## Technical Memorandum

Subject: **Response to Comments and Addendum to Groundwater Well Installation and Monitoring Work Plan**  
Former Nachurs Alpine Solutions Facility  
101 North 1<sup>st</sup> Street, Sunnyside, Washington  
Ecology Cleanup Site ID: 14601  
Facility/Site ID: 29243

## Proposed Sample and Monitoring Well Locations

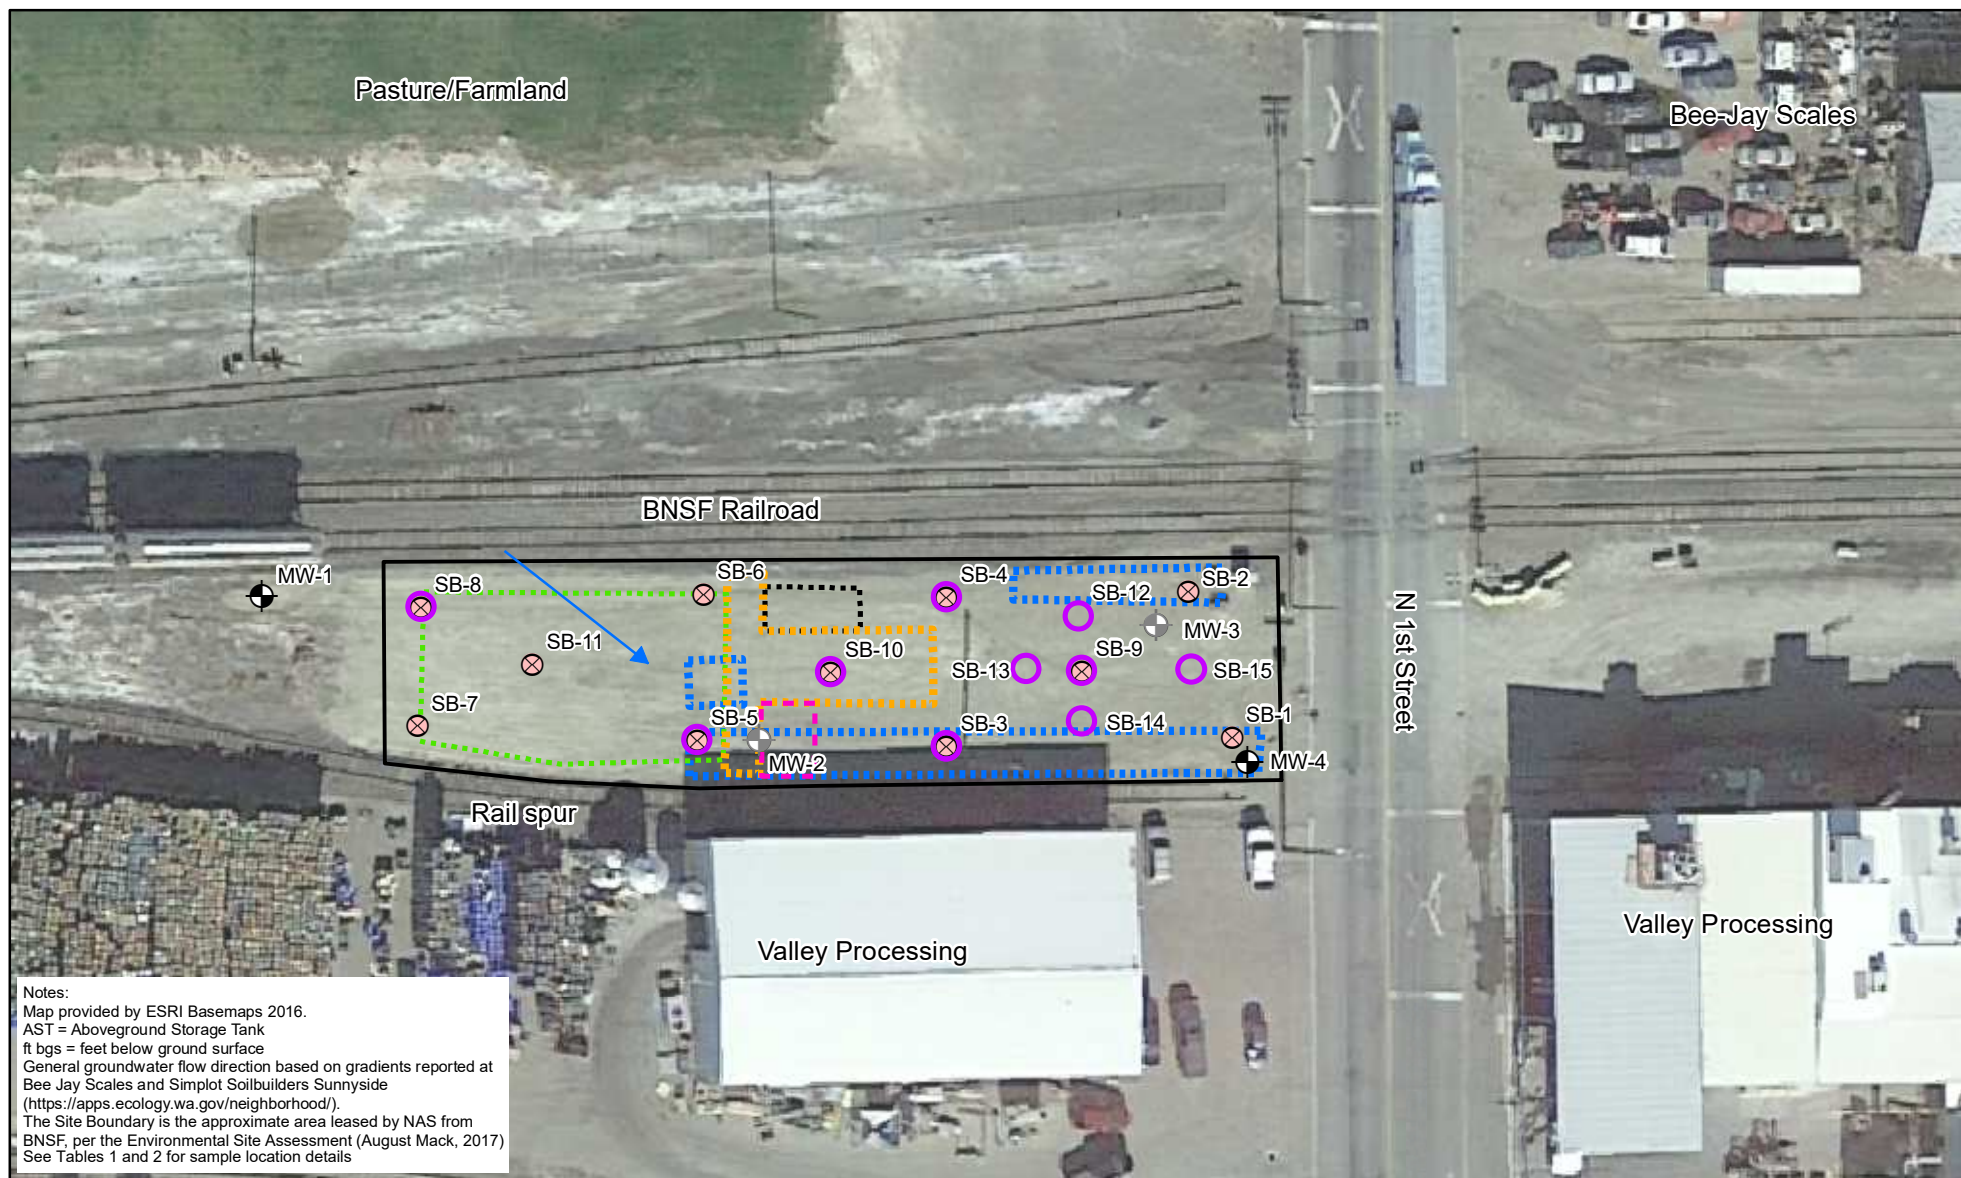
**Ecology Main Comment #1:** Ecology believes it is too early in the process to rule out soil impacts from NAS operations. As a result, Ecology recommends that soil samples, in addition to groundwater samples be collected. Ecology believes it would be beneficial to conduct additional soil and groundwater investigation at the other eight soil boring locations from the 2018 Limited Phase II Subsurface Investigation (Phase II)<sup>3</sup> that did not have groundwater samples collected. Ecology also recommends collecting additional soil and groundwater samples around grab-groundwater location SB-9, which showed higher concentrations of constituents of potential concern (COPCs) in the groundwater compared to the other two groundwater samples collected during the Phase II.

**Ecology Main Comment #4:** Ecology doesn't believe quarterly sampling is important right now and instead the focus should be identifying potential source(s) of contamination, and further delineation. However, Ecology recommends that if we choose to proceed with installation of the monitoring wells at this time, rather than a direct push investigation, shifting the locations of MW-2 and MW-3 to the southwest slightly to be directly downgradient of the former above ground storage tank (AST) areas.

*Response: NAS will collect soil samples at a subset of the eight soil boring locations from the Phase II in addition to four proposed new locations that are step-outs to assess lateral extent of impacts around SB-9. The proposed locations are shown in the Revised Figure 2 attached. A*

*Proposed well locations for MW-2 and MW-3 will be adjusted per Ecology's suggestion, and approximate revised locations for these wells are shown in Figure 2. These locations will be refined based on results from the proposed additional soil and grab-groundwater sampling (see response to Ecology Main Comment #1). The proposed monitoring well locations for MW-1 and MW-4 will remain at their originally proposed locations, designed to monitor groundwater entering (background) and exiting the Site, respectively (Figure 2).*

Consistent with the Work Plan, four monitoring wells will be installed at the Site. Proposed monitoring well locations MW-1 and MW-4 will remain the same as outlined in the Work Plan (Figure 2). MW-2 and MW-3 locations will be selected following a review of findings from Phase 1 of the investigation. During installation of the four monitoring wells, two soil samples will be collected at each well location (0-3 and 4-6 ft bgs). Soil samples will be analyzed for metals (arsenic, cobalt, molybdenum, and nickel) by EPA Method 6020 (or equivalent) and nitrate as nitrogen by EPA Method 300.0 Modified (or equivalent).
